1241 HARWOOD STREET (COMPLETE APPLICATION)  
DE415100 - ZONE RM-5A

**DEVELOPMENT PERMIT STAFF COMMITTEE MEMBERS**

**DEVELOPMENT PERMIT STAFF COMMITTEE RECOMMENDATION: APPROVE**

Figure 1. Shadow diagram of hypothetical building at 2.2 FSR and 110 ft. in height

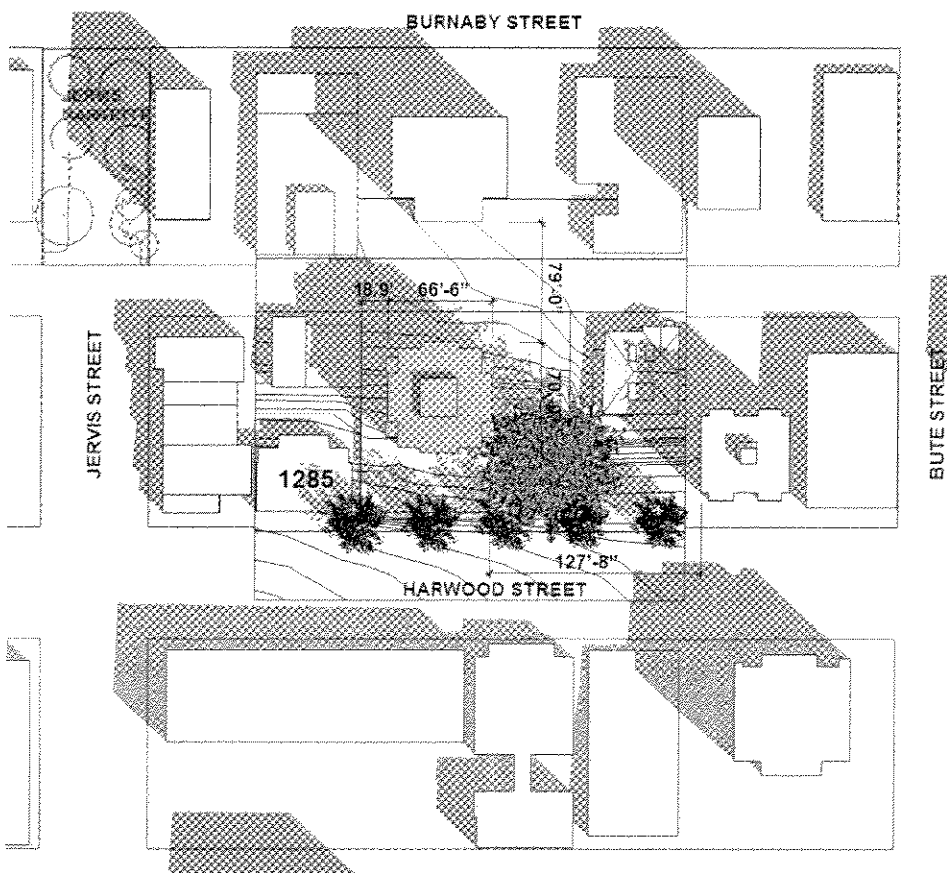
When considering the standard dates of the spring and fall equinox, the shadow of the proposed building does not reach any public green space. The proposed building will shadow the residential courtyard to the west during the morning. By 12:00 noon the shadow has cleared the open space. However, a tower with a more typical building width at the same density would create worse effects, as illustrated in Figure 1.

Figure 2. Site plan comparison showing proposed design and hypothetical tower

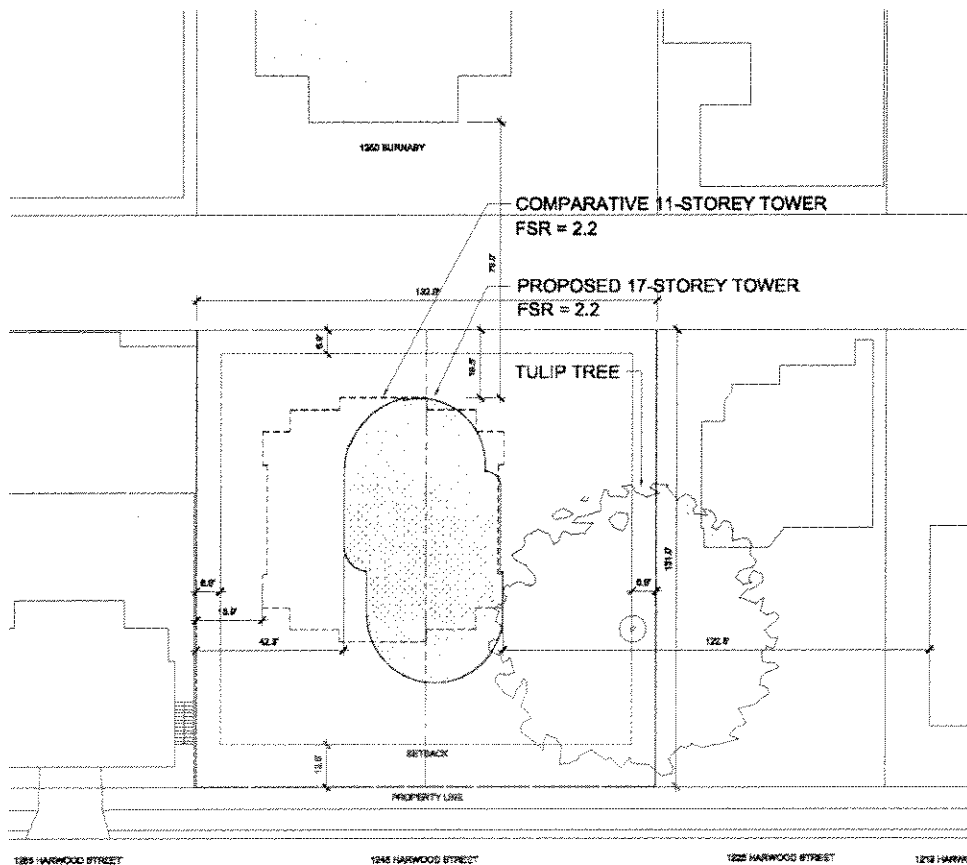
*Privacy:* The Guidelines strive for development that provides adequate privacy for new and existing residents. Retention of the tulip tree helps with privacy to the east because of the horizontal space it requires, as well as providing a green screen for upper floors when in leaf. Due to the narrow floor plate, the west side yard is significantly larger than required, as shown

in Figure 2. Some adjustment at the lower floors of the building is recommended to improve privacy for the closest neighbours (Standard Condition A.1.1 [i]).
